ADDENDUM 001

Date: **May 27, 2026**
To: **Construction Documents, Dated 05.18.26**
Project: **#3038 ASU Career Readiness, Education, & Skills Training Center**

WATER MAIN PLAN & PROFILE
C2.10

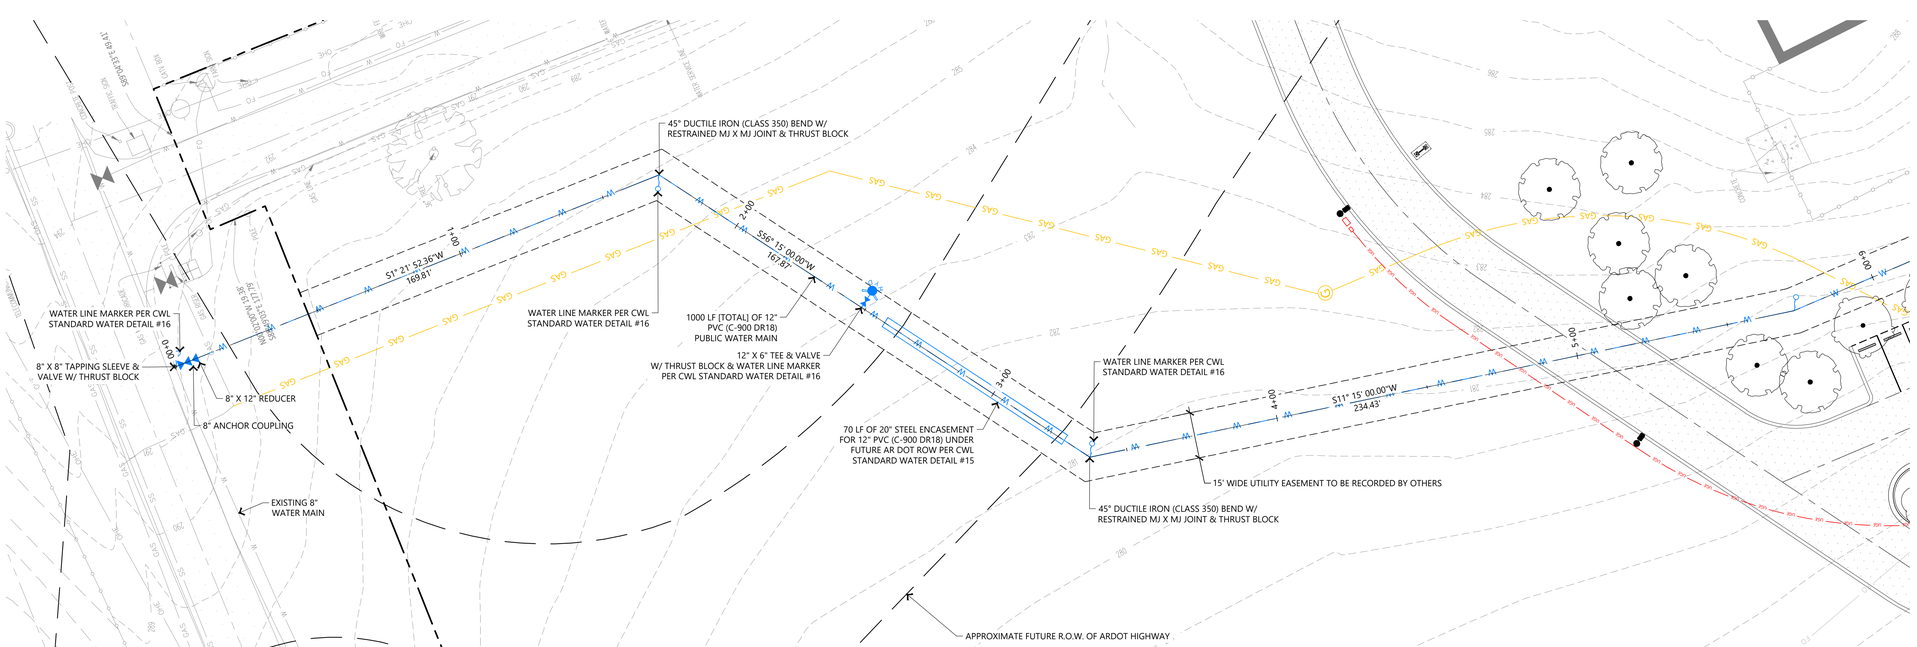
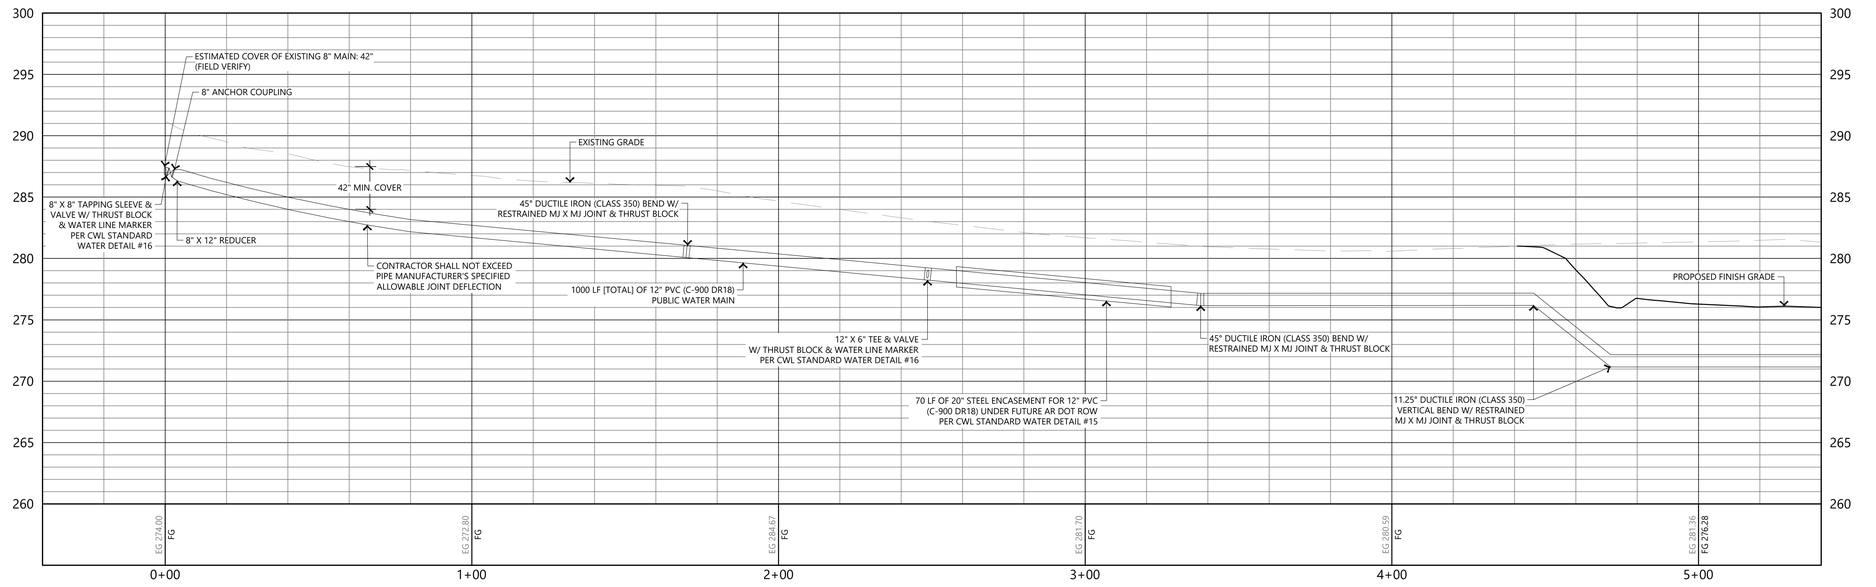
C2.10	Water Main Plan & Profile	1. Water main now is proposed to connect on south side of Aggie Road at the Longhorn Drive intersection. A proposed public utility easement is now shown. All water lines have been revised accordingly. 2. Proposed Water Main Shall be C-900 PVC (DR18). 3. Water line markers are indicated at all bends and beginning and ends of main. 4. A fire hydrant has been added on the north side of the future ARDOT ROW. 5. Added 811 logo to titleblock.
C2.11	Water Main Plan & Profile	1. Water main now is proposed to connect on south side of Aggie Road at the Longhorn Drive intersection. A proposed public utility easement is now shown. All water lines have been revised accordingly. 2. Proposed Water Main Shall be C-900 PVC (DR18). 3. Water line markers are indicated at all bends and beginning and ends of main.

4. A fire hydrant has been added towards the end of the water main to be plugged for future. 5. Water meters and fire line demarcation valve are now located on the east within the proposed public utility easement. 6. Added 811 logo to titleblock.
C2.20	Supplemental Utility Notes	1. New sheet with CWL required notes for utilities. These notes are additional to the Utility Notes located on the C0.00 General Notes & Legends sheet.
C3.02	Grading & Drainage Plan	1. Curb and gutter has been added around the proposed private fire hydrant and PIV (at the southeast corner of the building) 2. Added 811 logo to titleblock.
C4.00	Overall Erosion Control Plan	1. The limit of disturbance line has been adjusted due to no longer performing water line installation in these areas. 2. Added 811 logo to titleblock.
C4.01	Erosion Control Plan	1. The limit of disturbance line has been adjusted due to no longer performing water line installation in this area. 2. Added 811 logo to titleblock.

INTERIOR FLOOR PLAN
A2.01

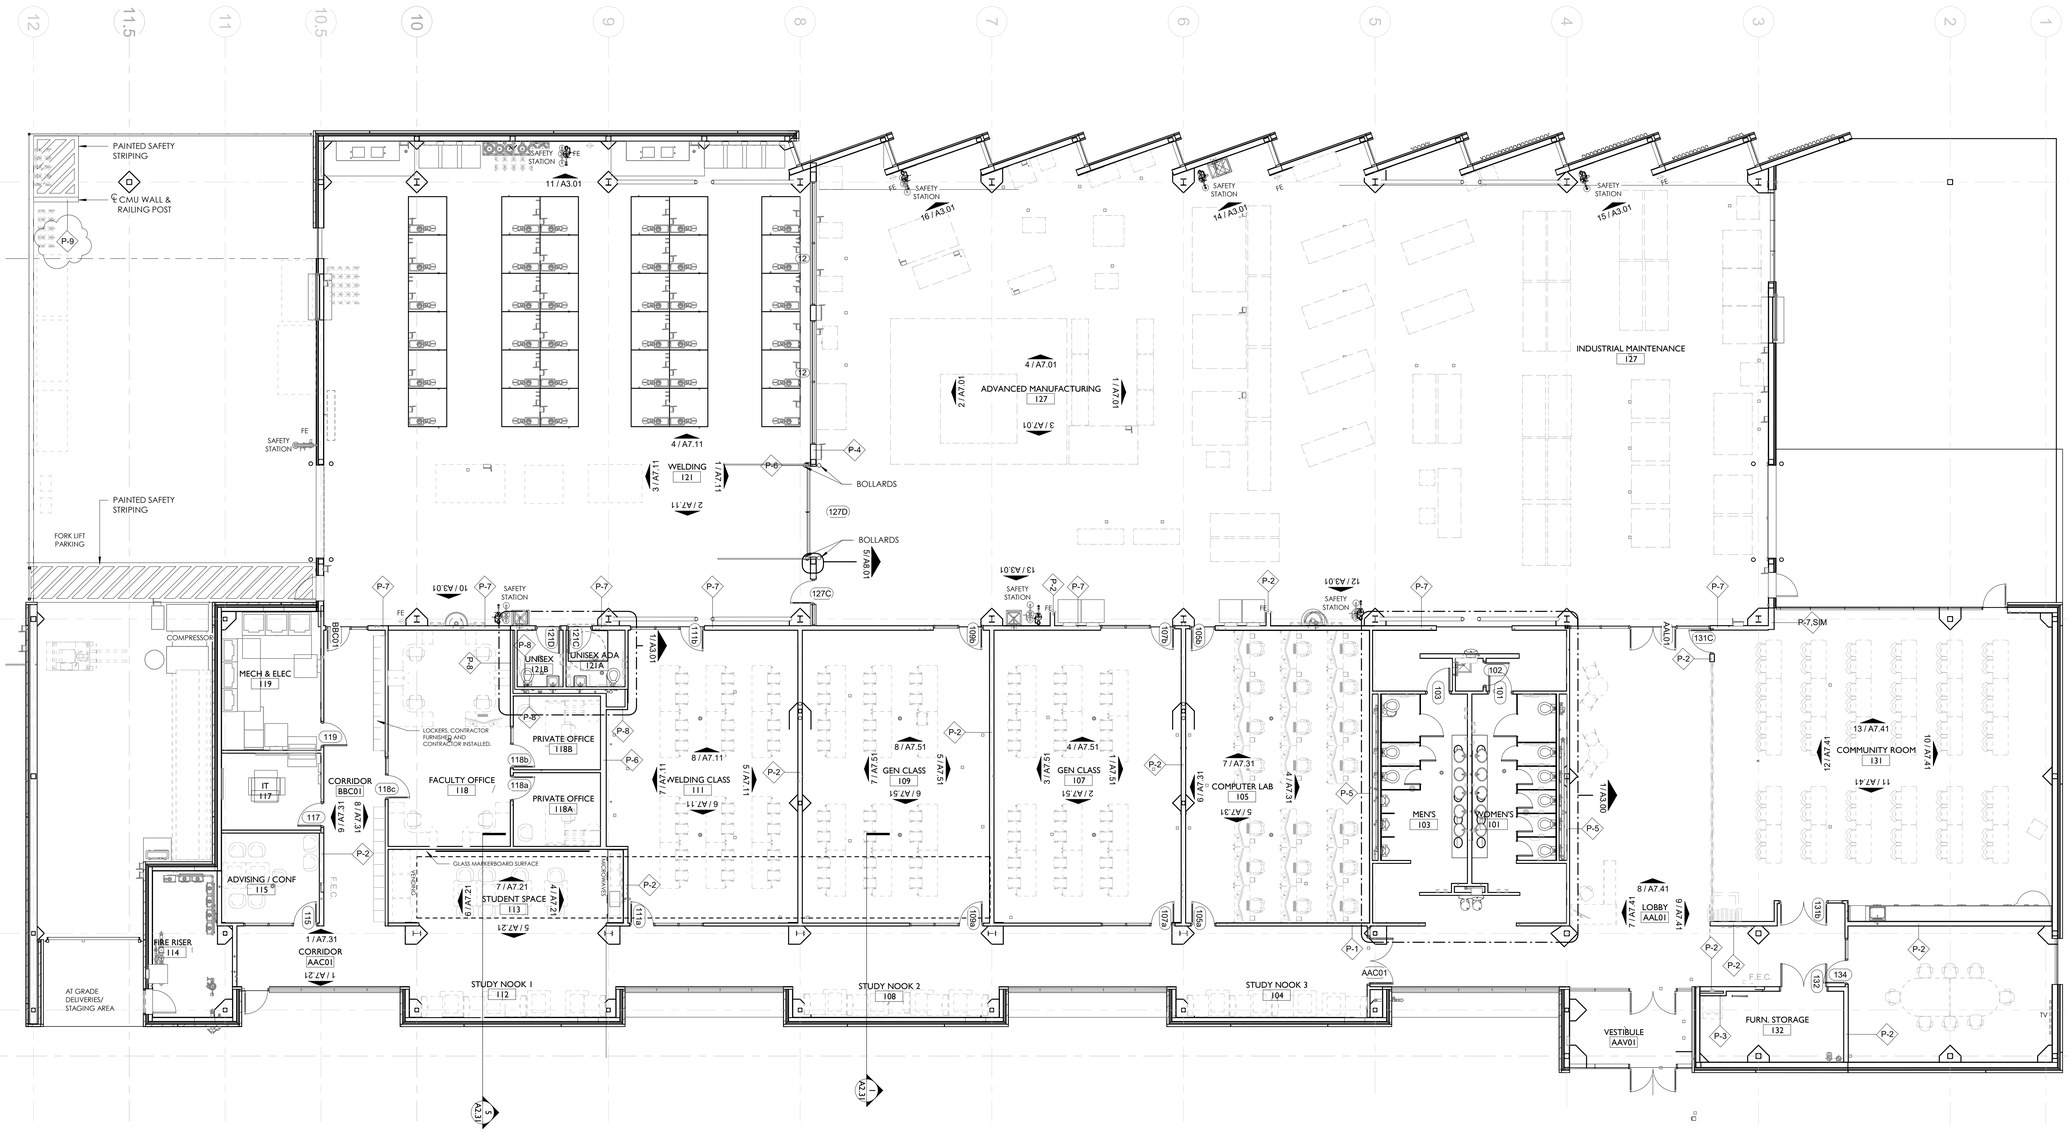
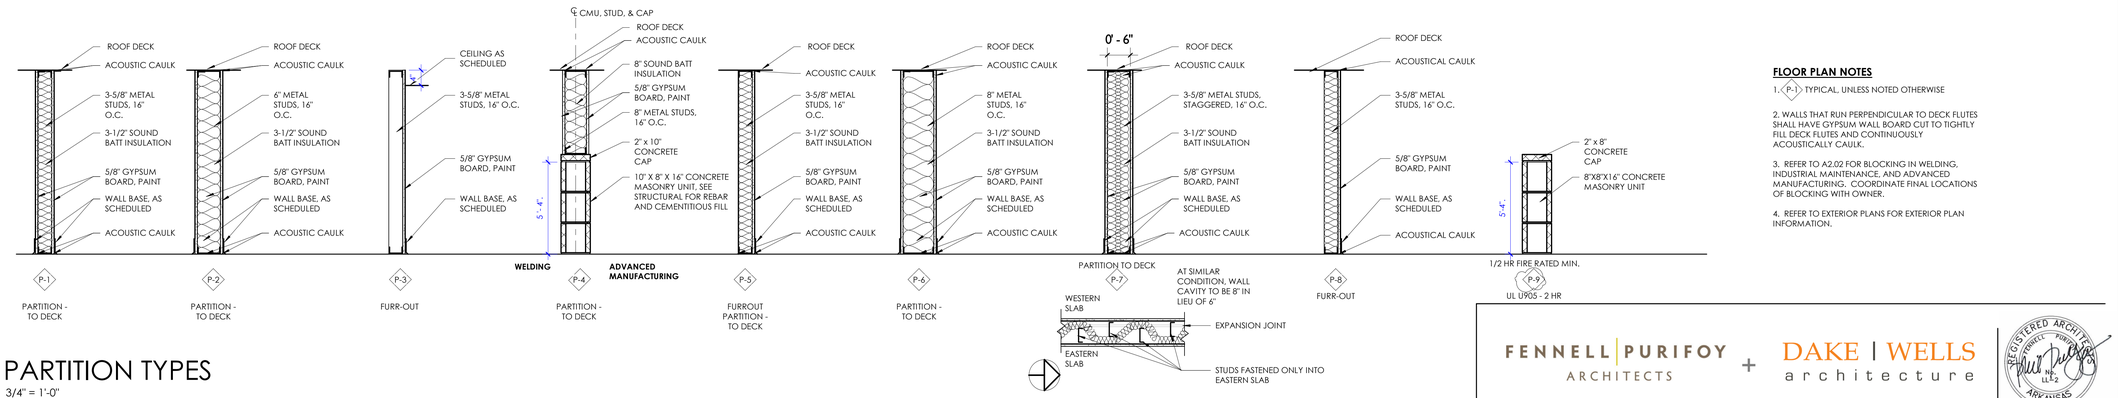
d. **REPLACE** Sheet A2.01 INTERIOR FLOOR PLAN with the attached for the following revisions:
   1. **REVISE** Partition Types to **ADD** P-9 and remove the duplicate P-7 type.

INTERIOR REFLECTED CEILING PLAN
A2.21

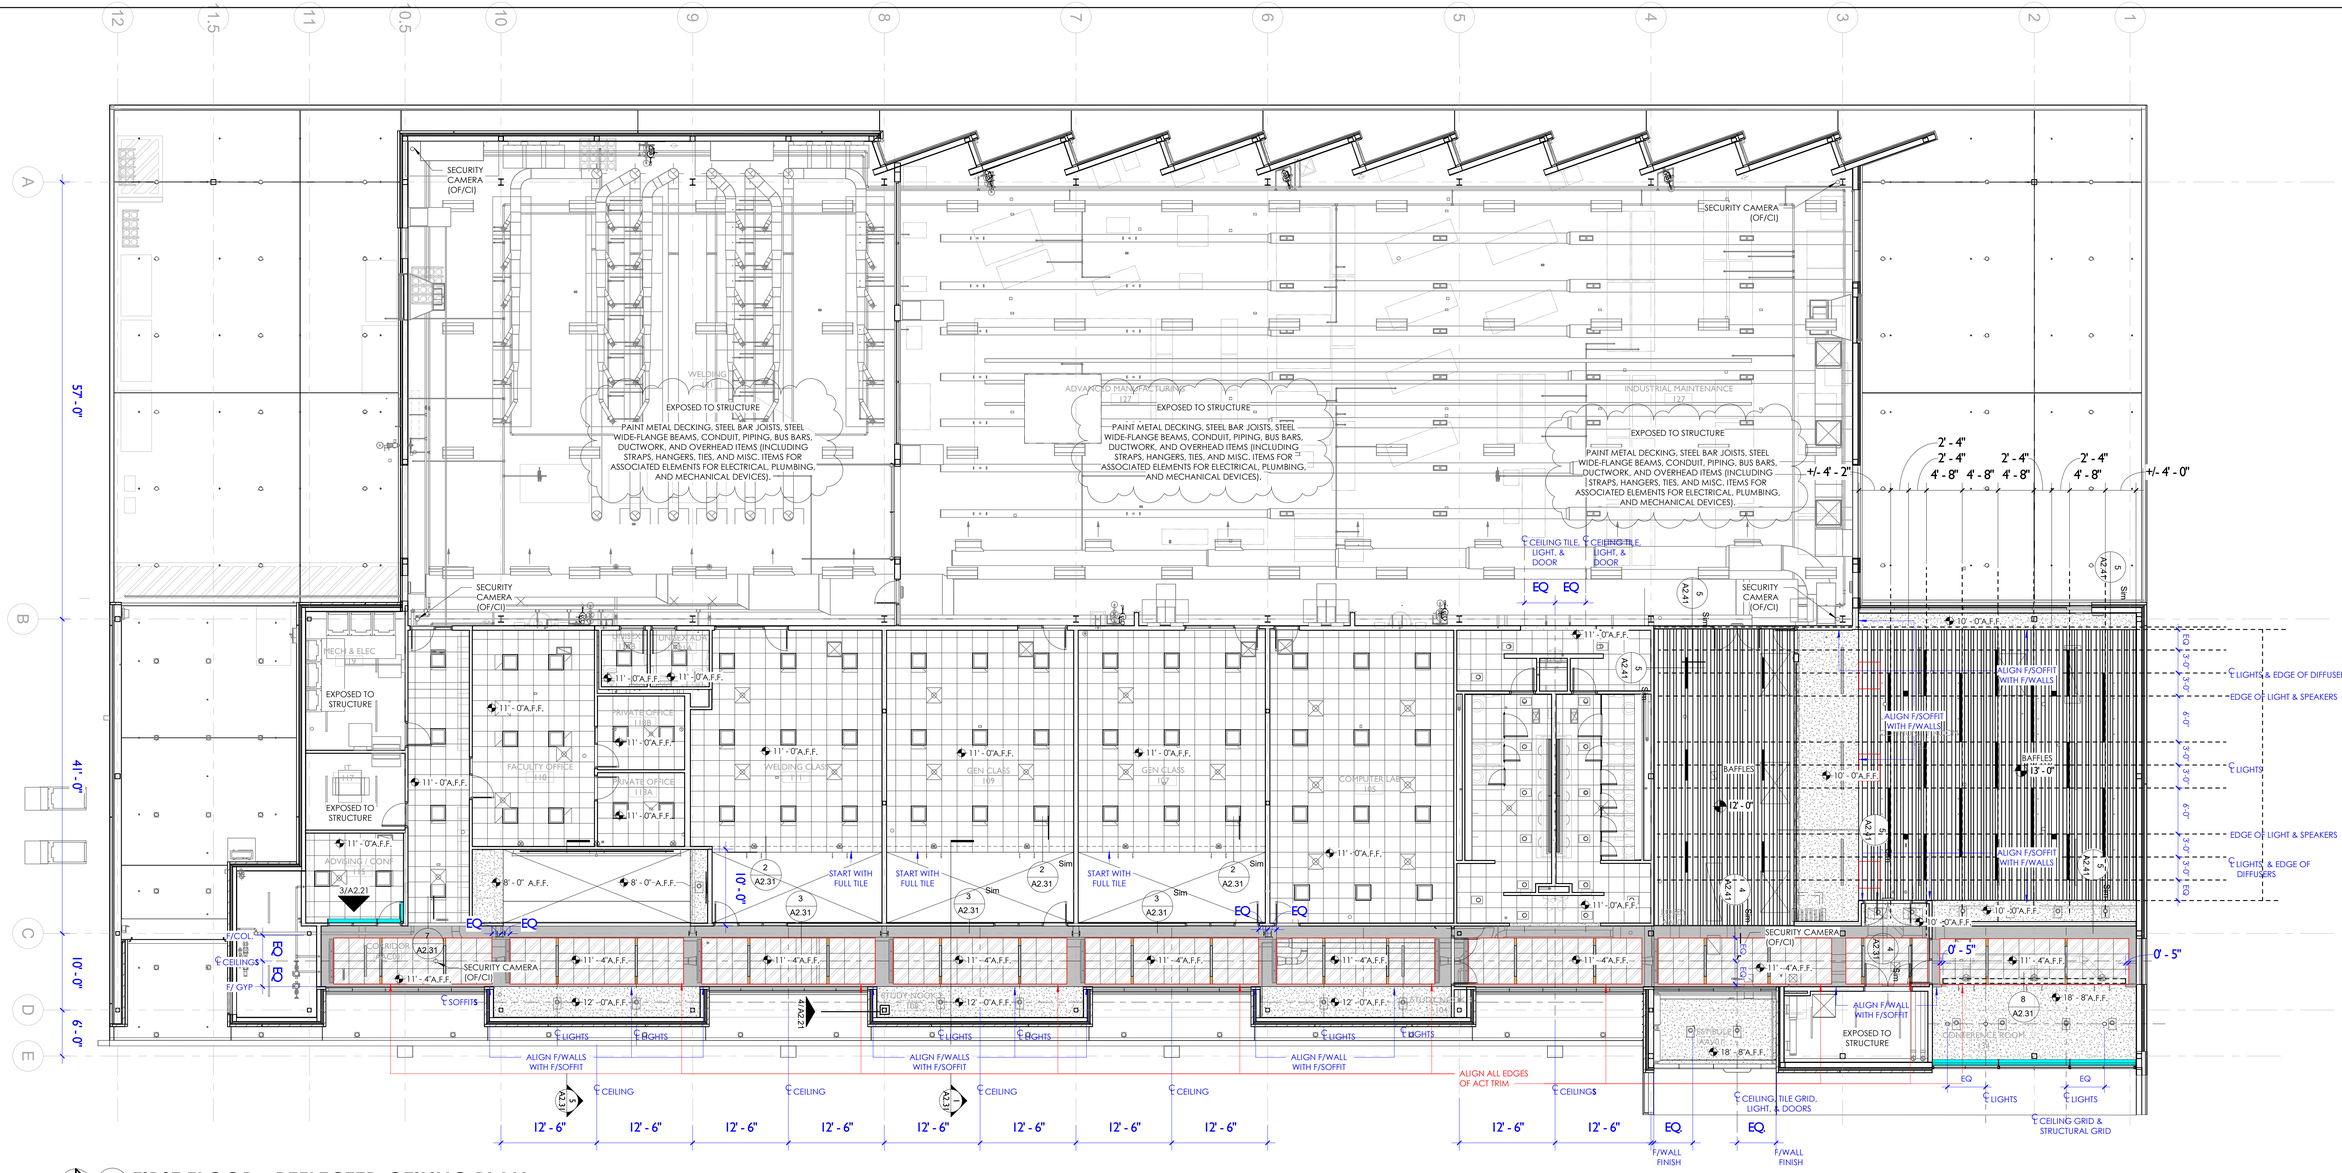
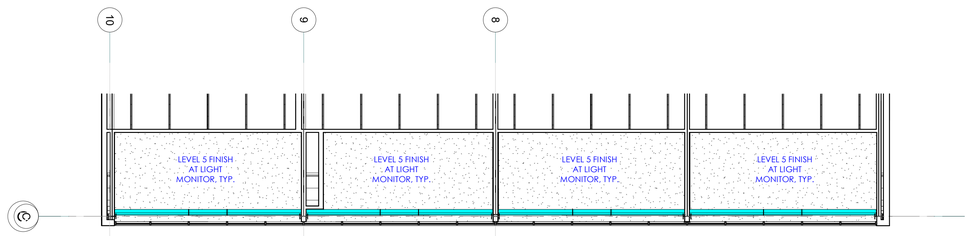
e. **REPLACE** Sheet A2.21 INTERIOR REFLECTED CEILING PLAN with the attached for the following revisions:
   1. **ADD** Note for painted decking and overhead components to 121 Welding, 127 Advanced Manufacturing, and 127 Industrial Maintenance.
